BOARD OF ADJUSTMENT – APPLICATION FOR A VARIANCE

## RESPONSE LETTER TO REVIEW COMMENTS

Arch PN: 22039 7BCM  
Project: 7 Brew – Columbia, MO  
Address: 209 S. Providence Road

Subject: Denial Letter, City of Columbia, dated 11/8/22 from Columbia,  
MO  
Community Development

**C-201**  
 SITE PLAN

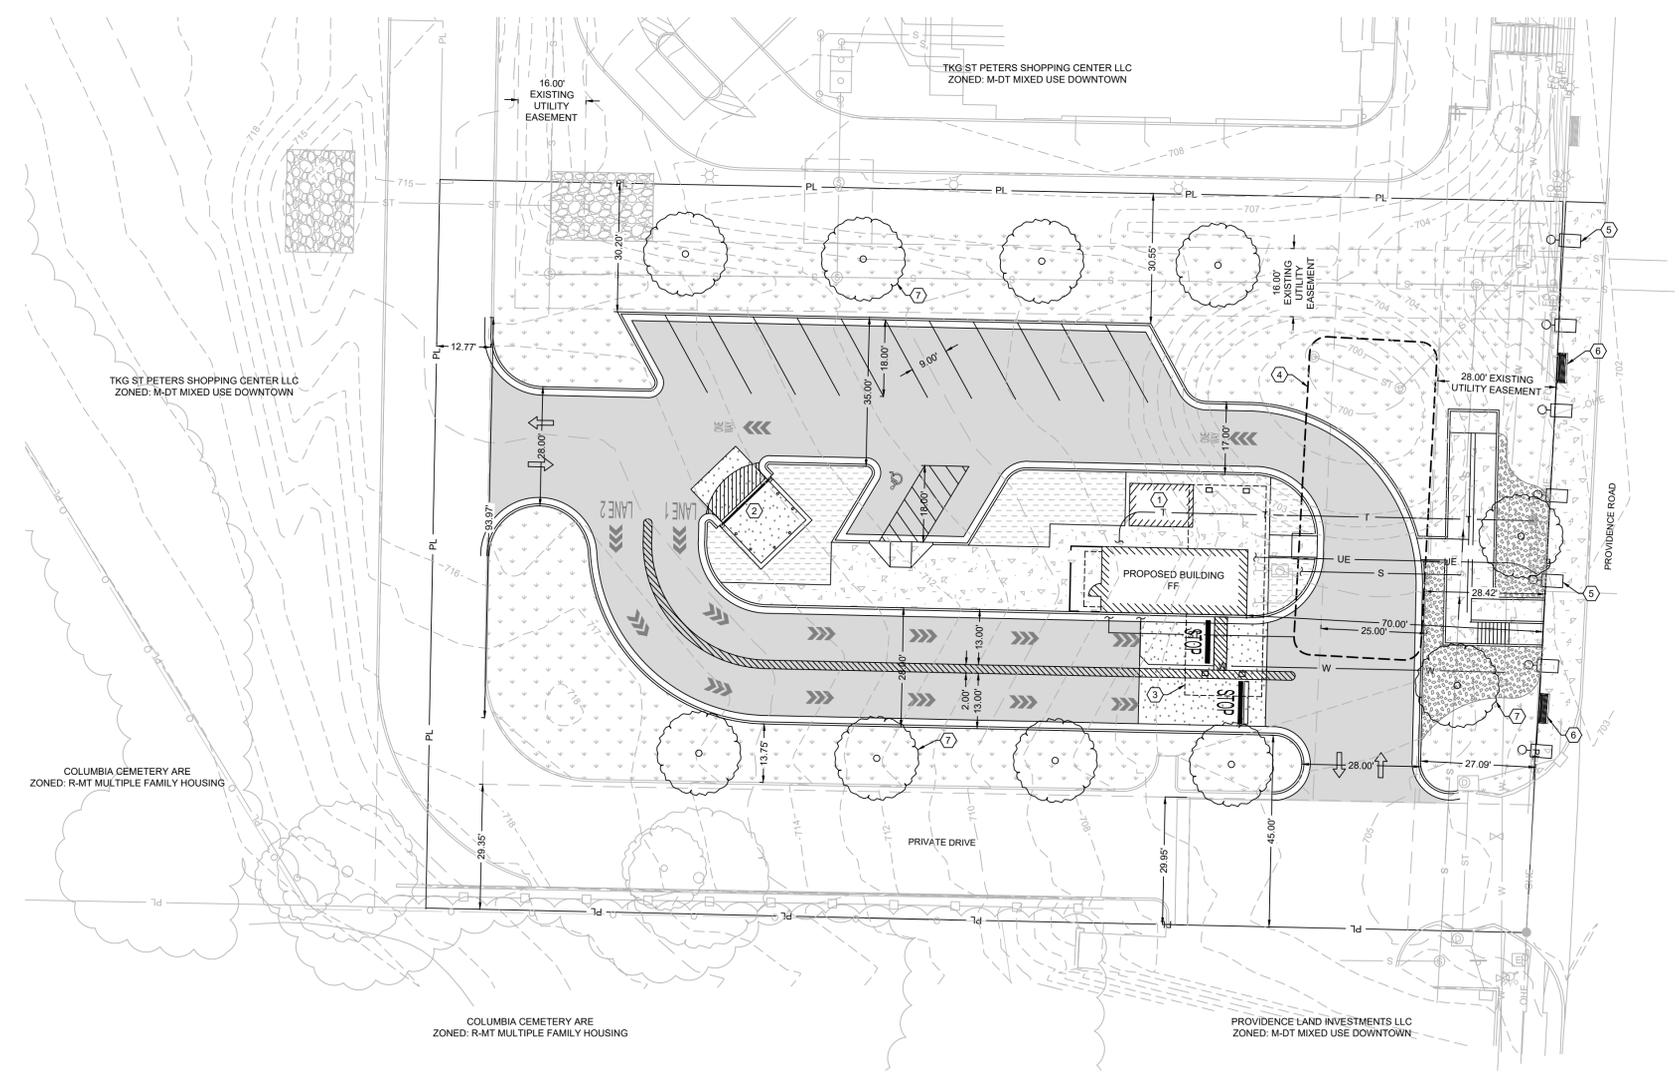
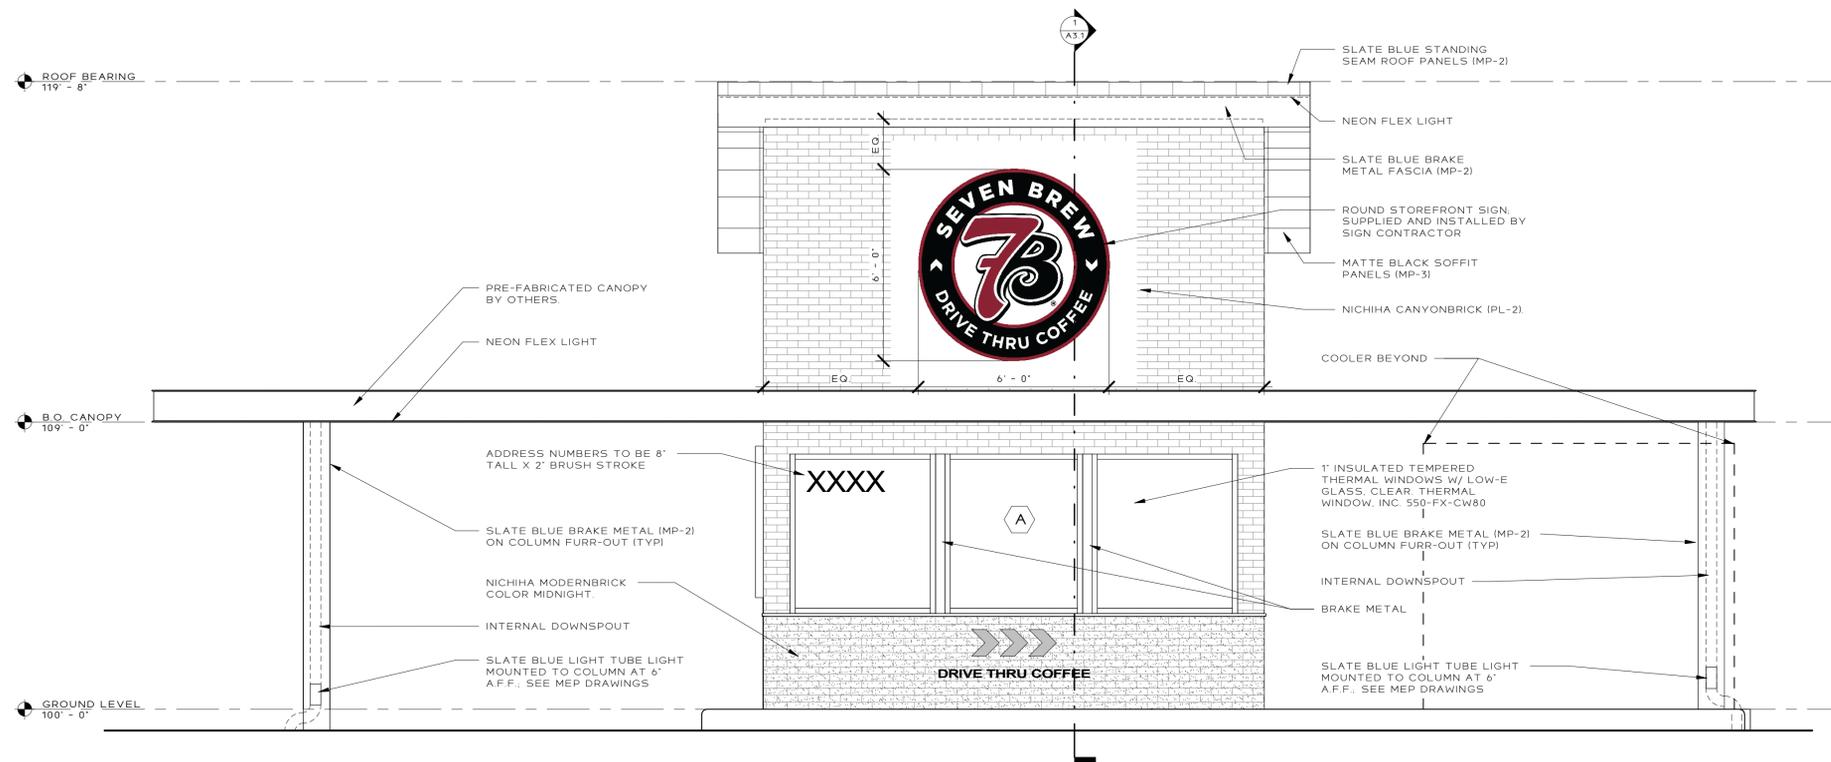
8. A bypass lane around the drive-through facility stacking lanes has not been provided. Section 29-4.3(i)(2)(vi).

9. Site exceeds the maximum number of parking spaces per Section 29-4.3(e)(1). The minimum required number of spaces is 3, the maximum is 5, and the provided parking is 14.

Response: Access easements surround the building and generally function as the required by-pass lane. Access easement abuts the south and west property line. Access easement serves our property and the adjacent property to the north.

Response: The number of off-site parking spaces provided is for the maximum number of employees working during a high demand shift. Providing off-street parking to our employees will keep street parking available for the public and open along the street.

**1 EXTERIOR ELEVATION - FRONT**  
3/8" = 1'-0"

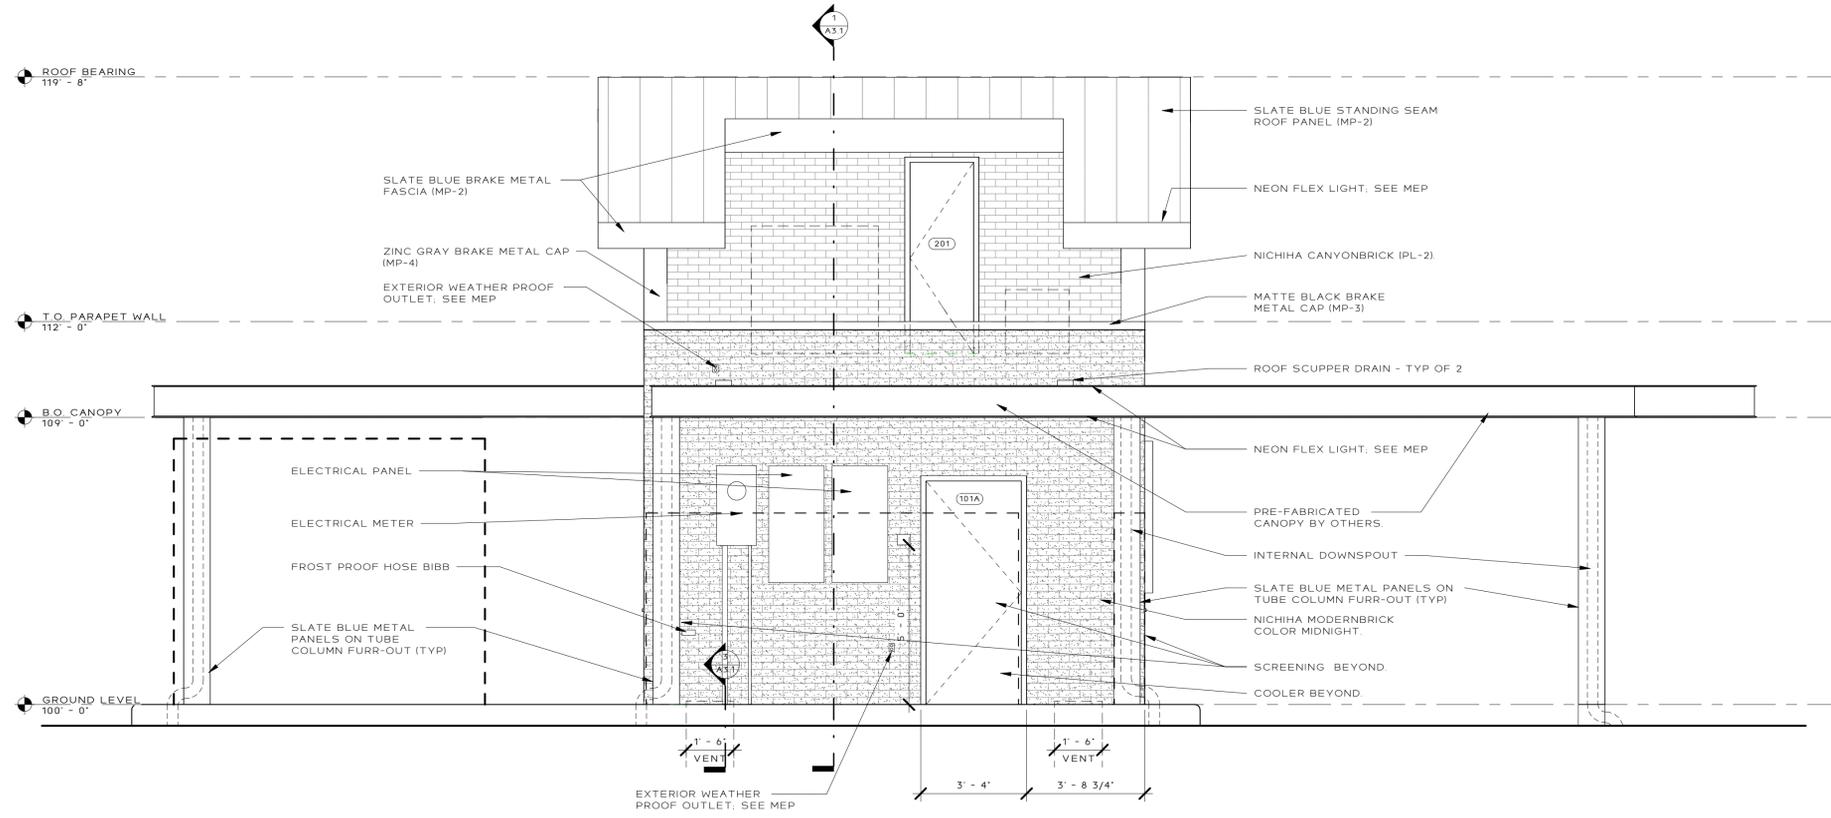
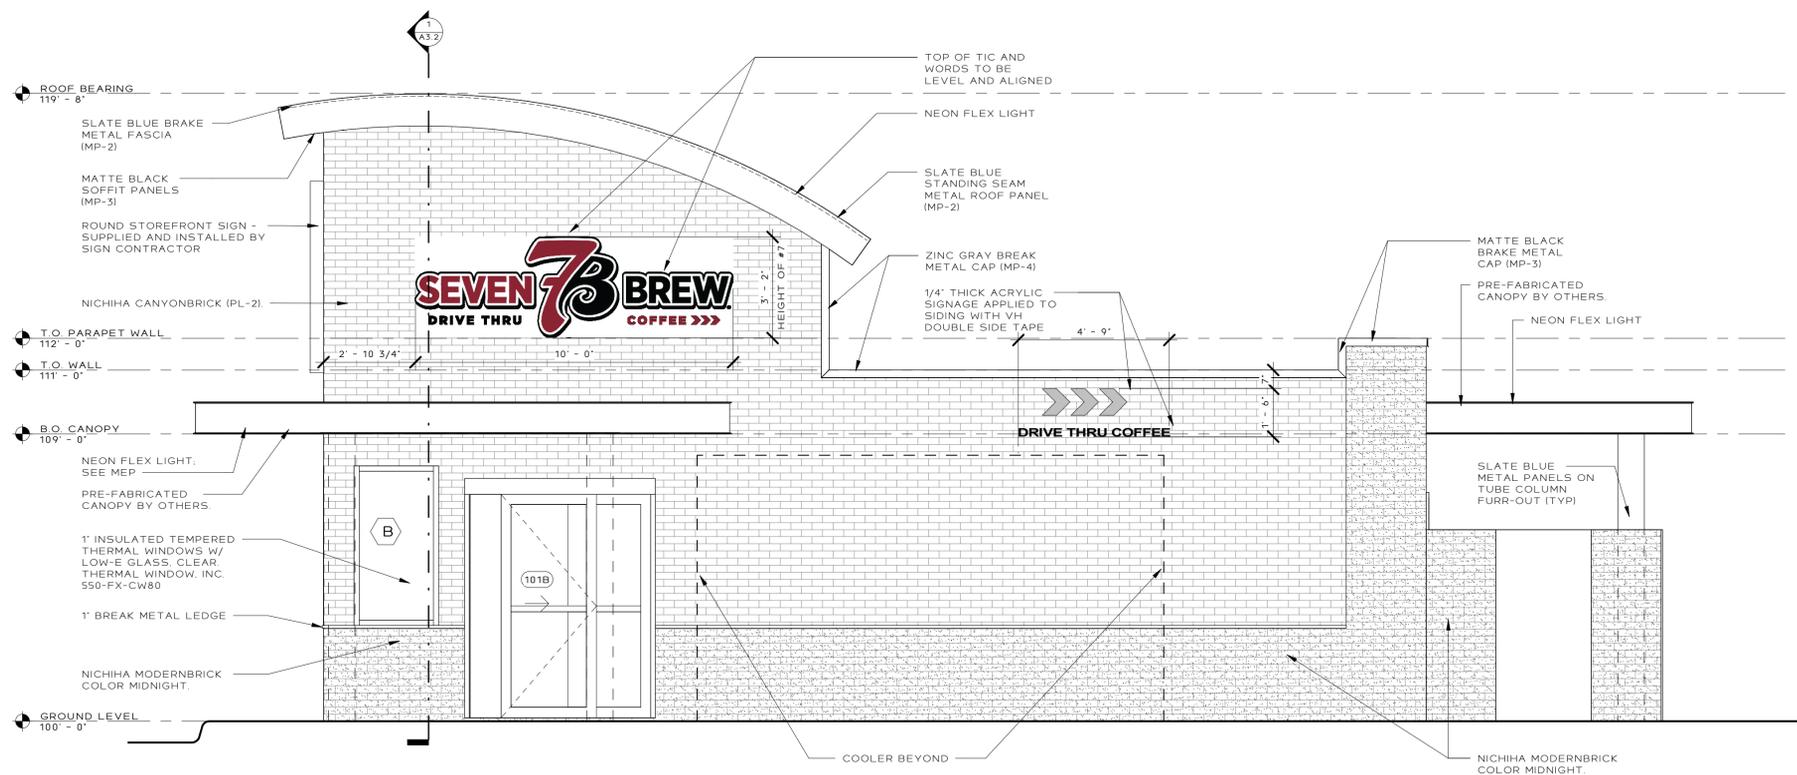
2. Ground story fenestration does not comprise between 33% and 80% of the ground story façade. Section 29-4.2(e)(2)(iv)(A)(2).

5. Each façade composition, regardless of the number of bays such composition may have, shall include a functioning street entry door. Section 29-4.2(d)(2)(iii).

6. Based upon the submitted elevation drawings it is unclear if the Ground Story clear height of 12 feet for the first 25 feet of building depth has been met as required by Section 29-4.2(e)(2)(ii)(B)(1)(b).

**2. Variance requested for this. We are currently providing 24%, which would be the maximum that we can feasibly do since the façade is small and we already have as much glazing as possible due to the kitchen equipment that's located behind the front wall.**

**5. Variance requested for this. An entry door would not be possible due to the kitchen equipment that's located behind the front wall.**

**6. Variance requested for this. Canopy is located 8'4" A.F.F.**
